Addendum #3

Date: August 22, 2013
PROJECT #: ET-0061-B01
New Joseph C. Caruso ES
DESCRIPTION: Addendum #3

G2 SITE PLAN
1" = 30'

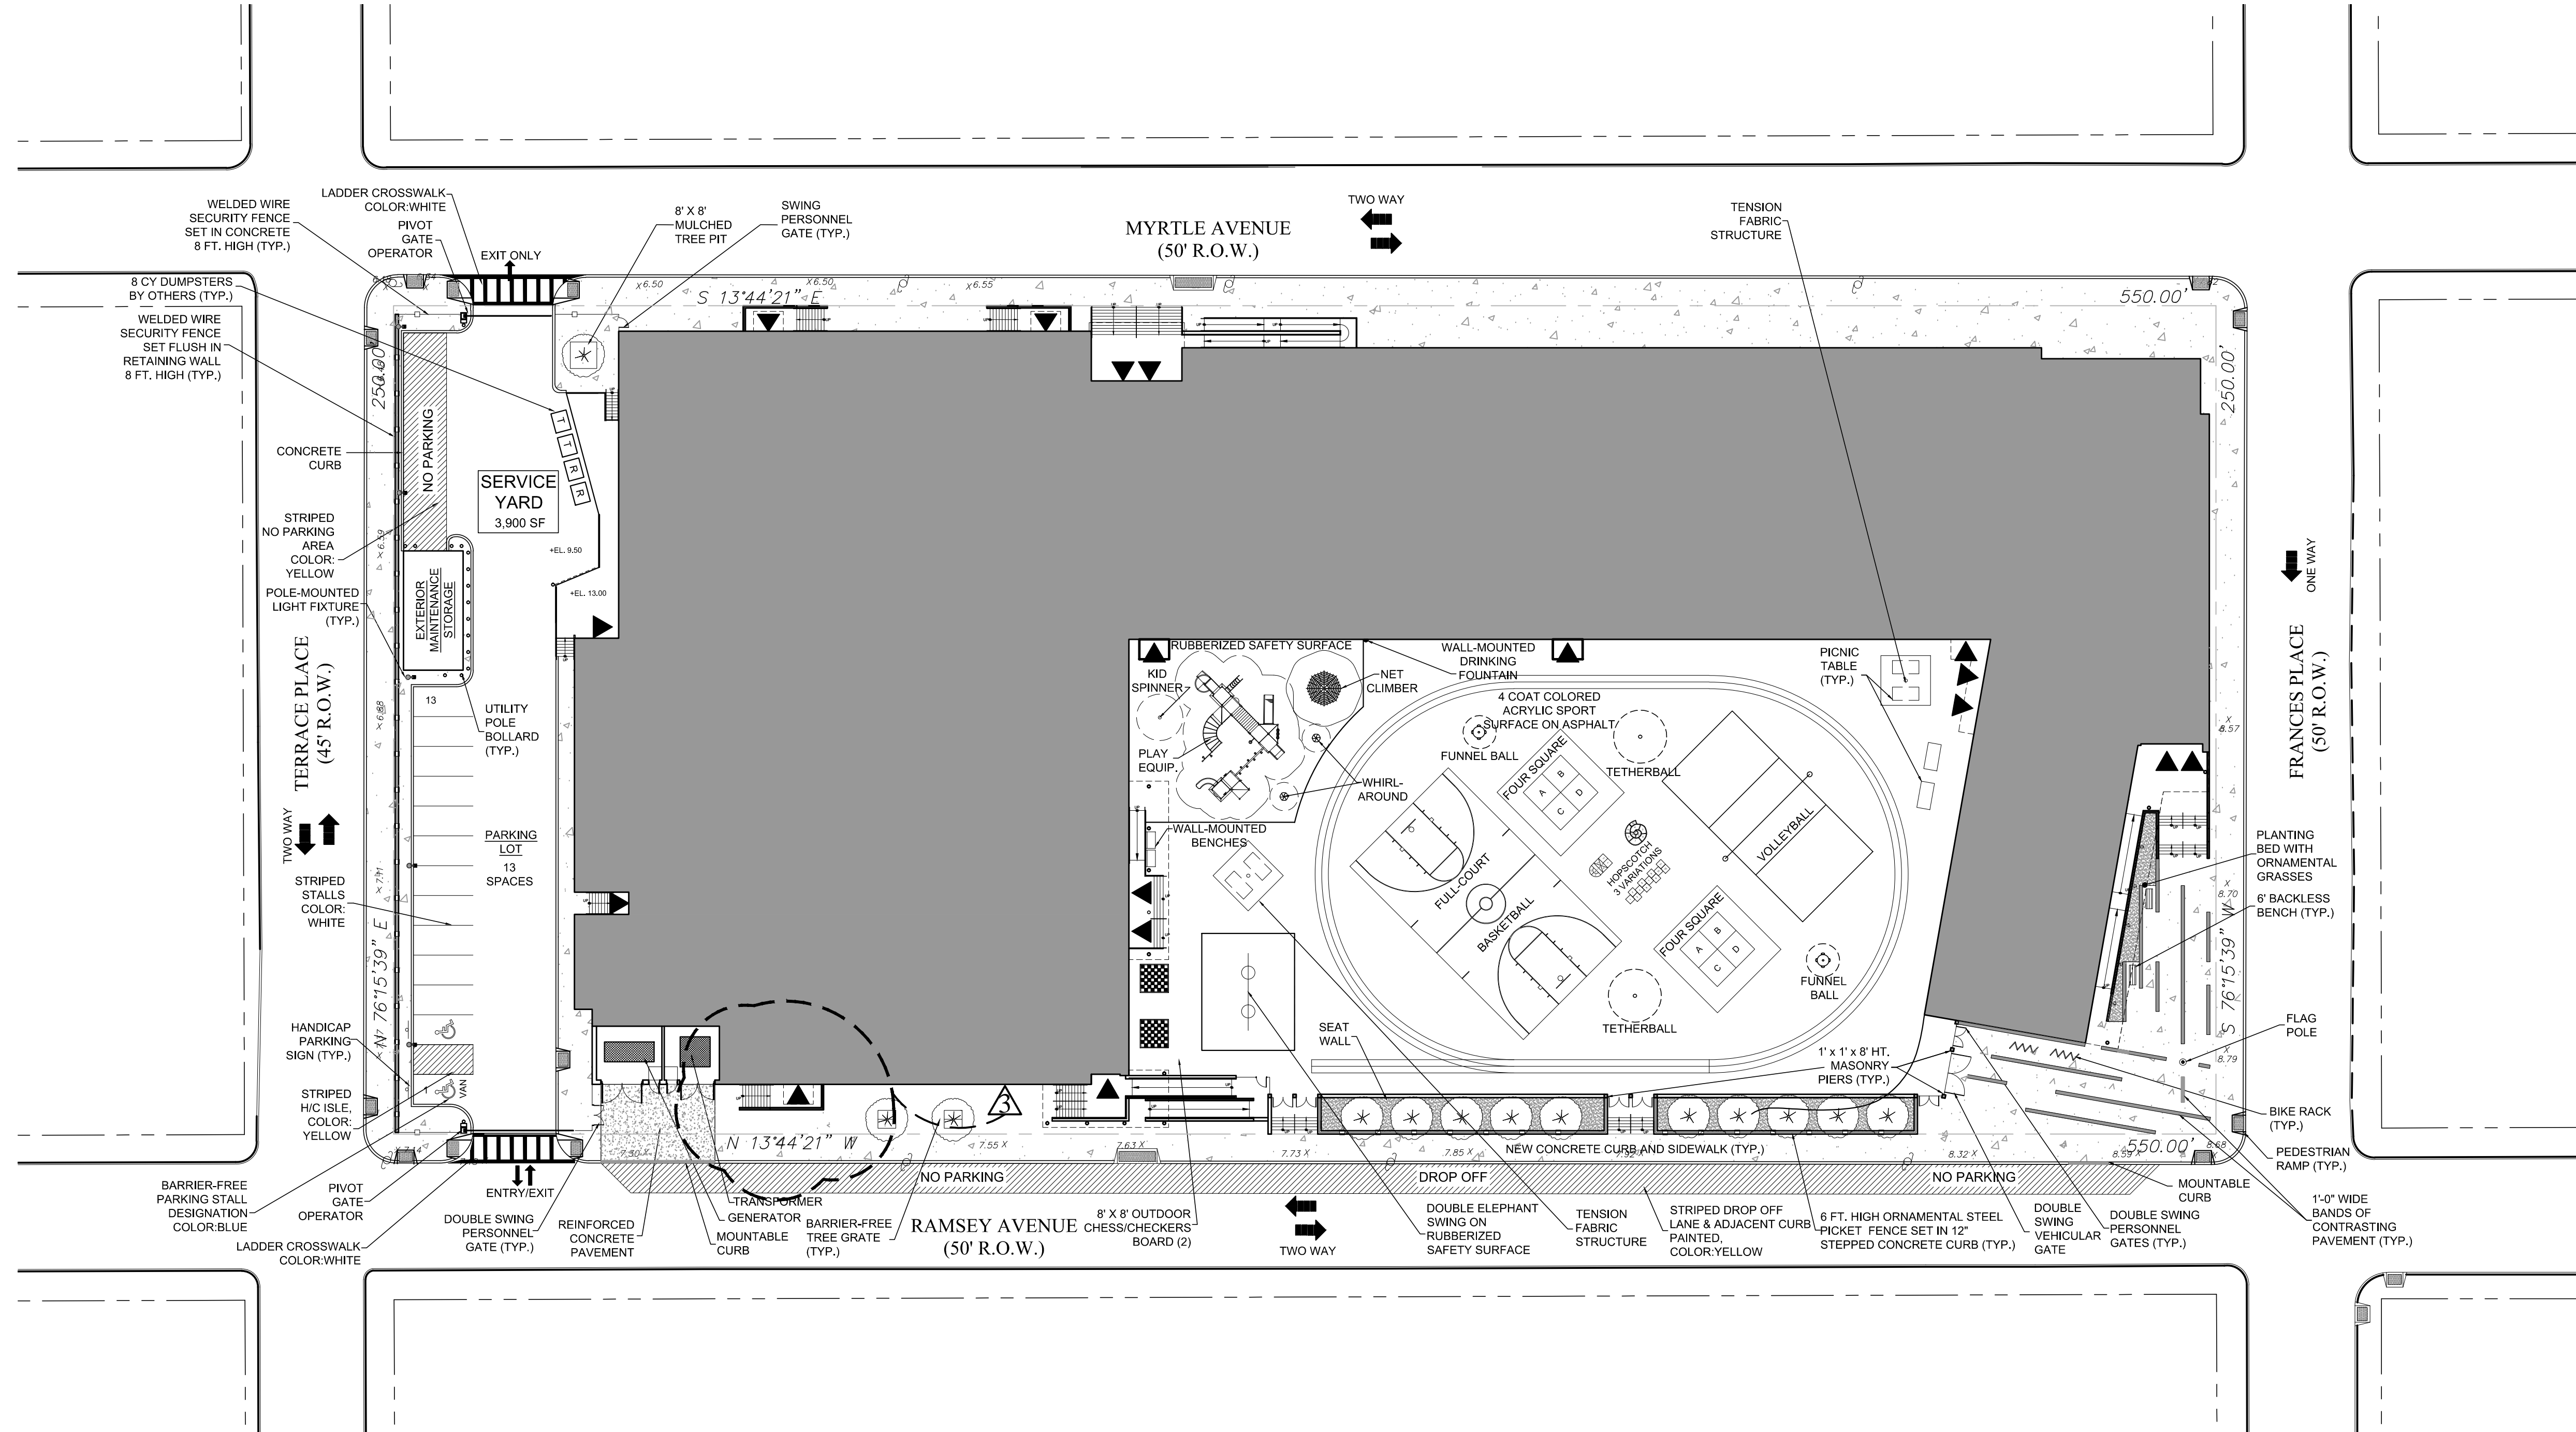
53. Question: The generator shown on Site Plan S-1 does not meet Best Practices Standards, which requires a separate fuel storage tank be physically separated from generators. Please revise.

Answer: The emergency generator shown on Site Plan S-1 is intended to be a natural gas generator and therefore, no fuel storage tank is required. Also refer to Materials and Systems Standards, Section D5010.10, Packaged Generator Assemblies.

FLOOR PLAN
@ SGI
CLASSROOMS

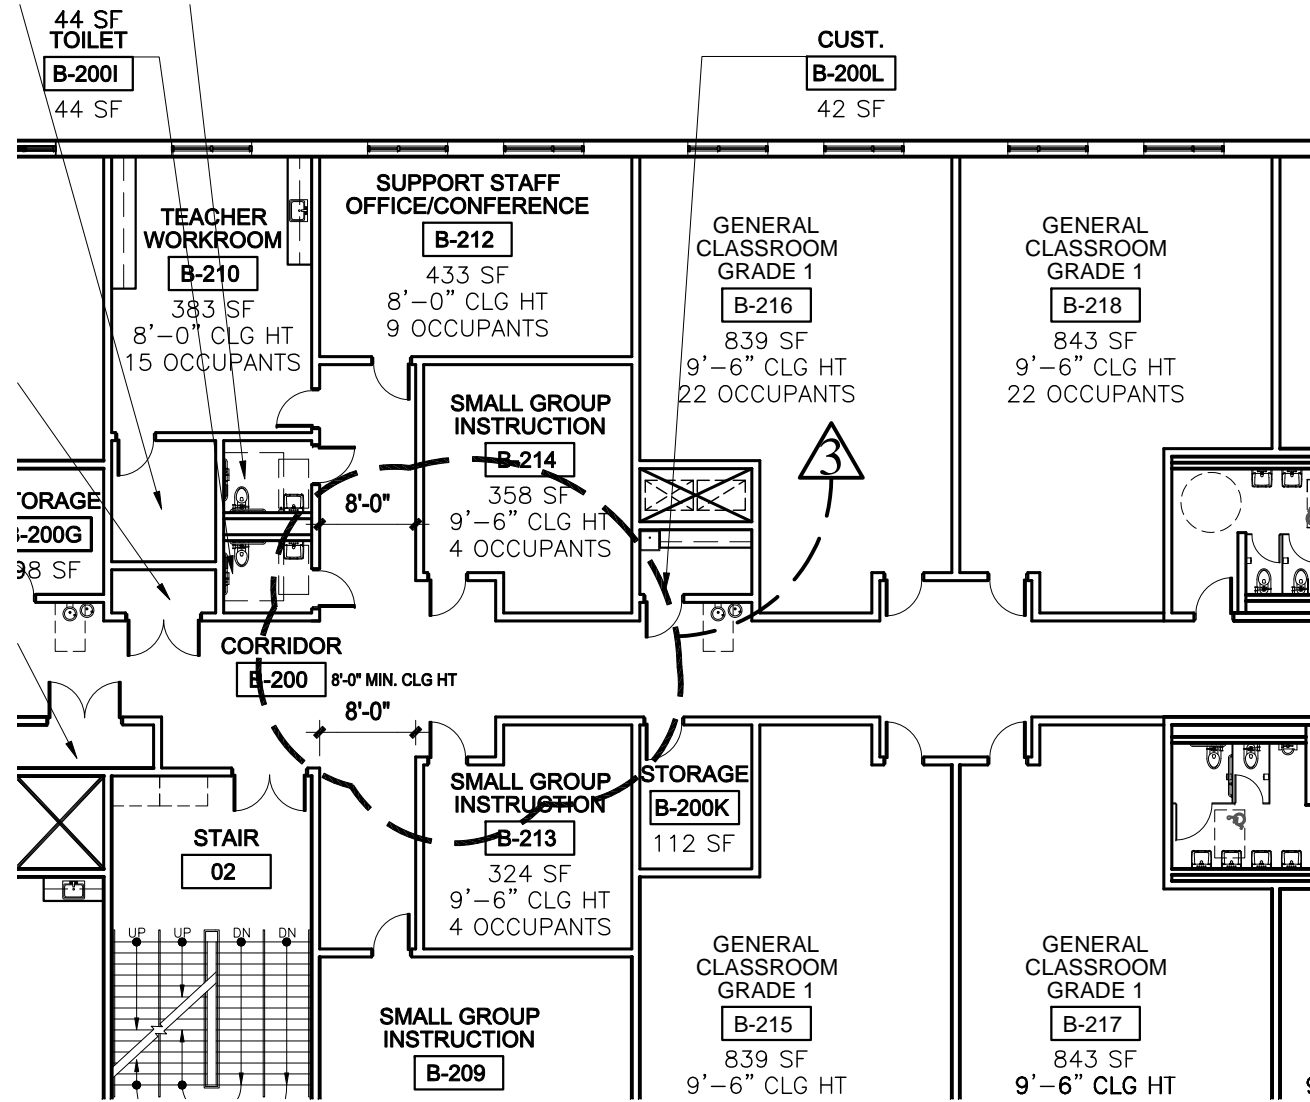
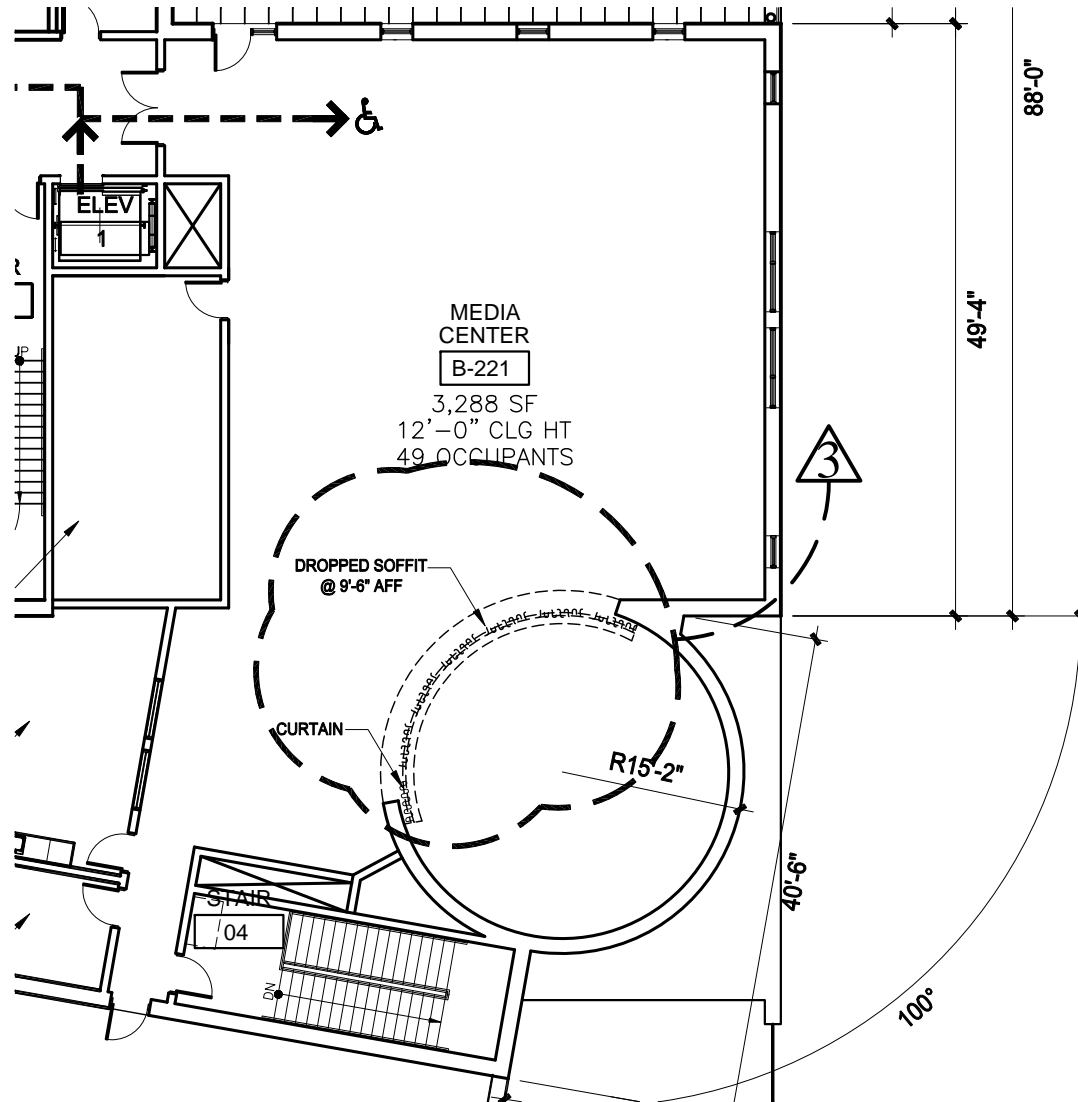
66. Question: The SGI classrooms shown do not meet code requirements. Doors to these classrooms must swing out into the corridor. Please revise.

NOTE: TYPICAL PLAN CHANGE AT ROOM NUMBERS B-111, B-114, B-213, B-214, B-311, AND B-314.

Answer: The door swings have been updated. See revised sheets contained within this Addendum (#3) for additional information.

IMMERSIVE
LEARNING
FLOOR PLAN

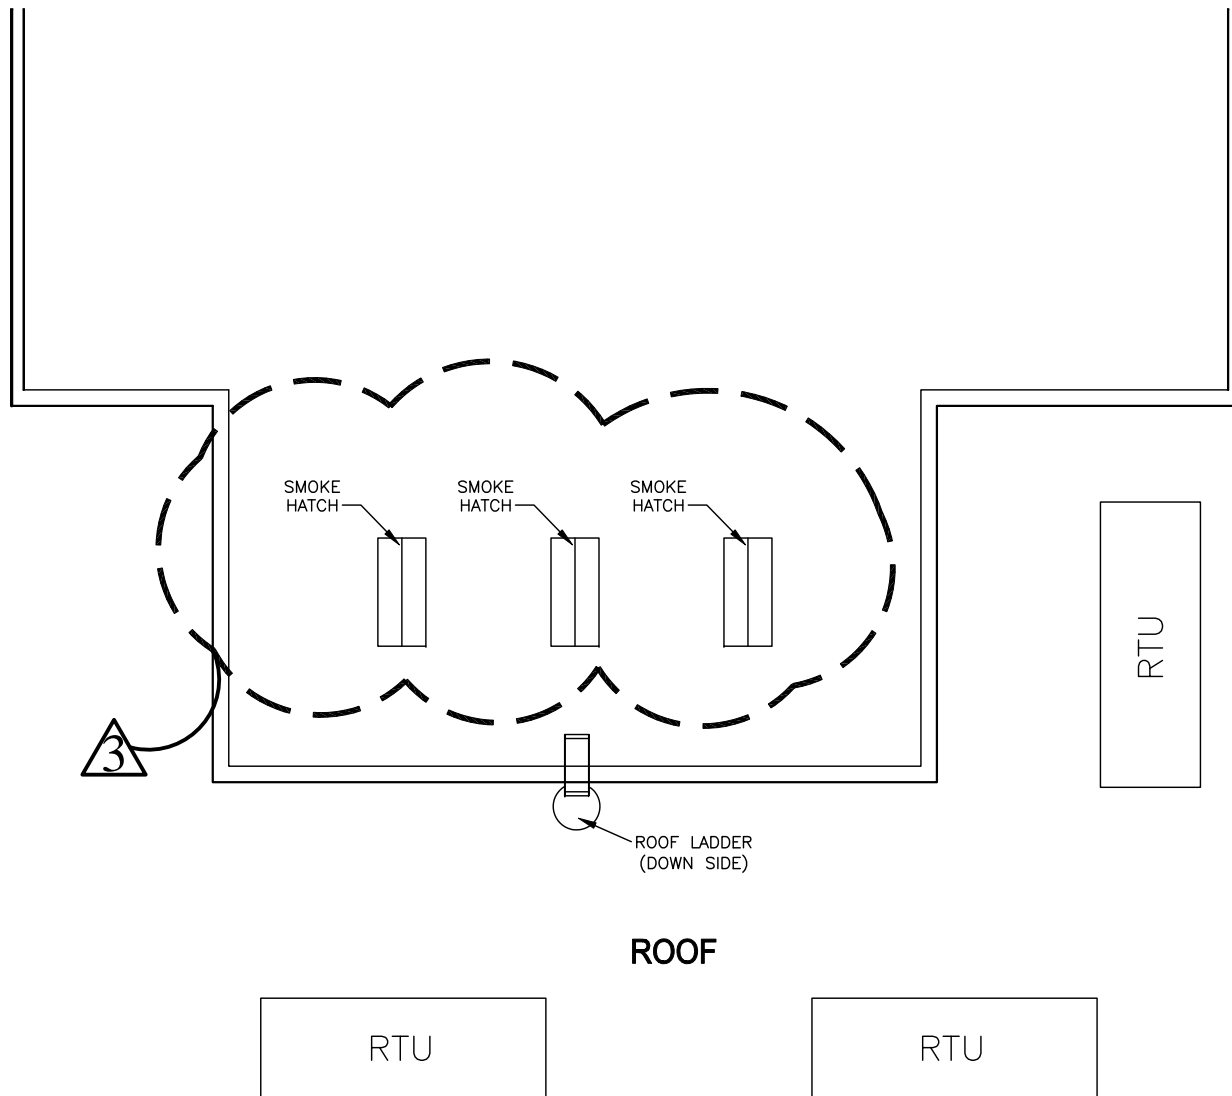
**2. Basis of Design for projection wall in Immersive Learning Area:
High-contrast screen coating by Goo Systems.**

(b) Multiple ceiling-mounted LCOS projectors, 1080p and 3D ready, with sound output integrated to item (a) above. Provide minimum four projectors or as required to cover proposed width of curved wall (240 degrees) in Immersive Learning Area.

REVISED
ELEVATION "F"

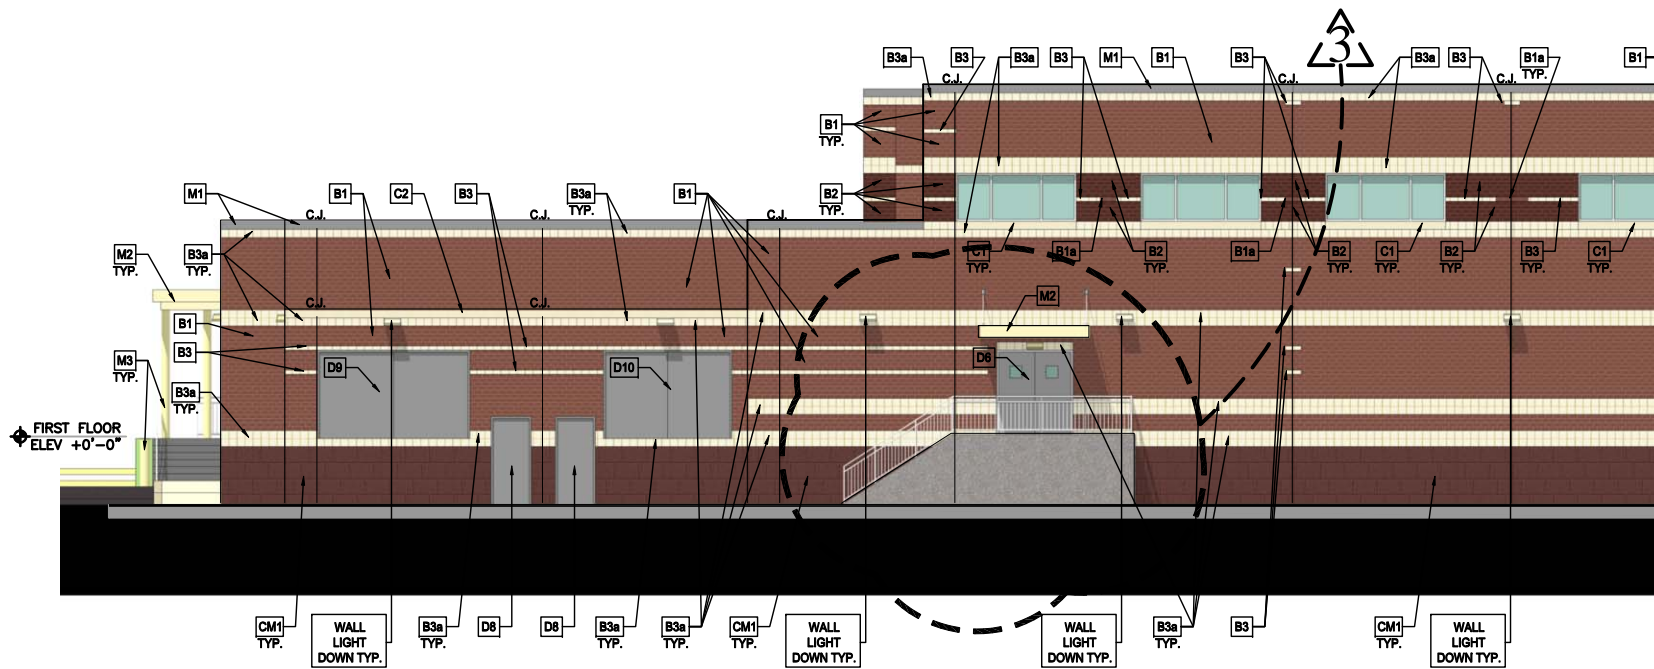
146. Question: Elevation D, Sheet A-5 and Elevation F, Sheet A-5.2 show man doors for generator and transformer rooms at grade but the larger doors above grade. Please clarify.
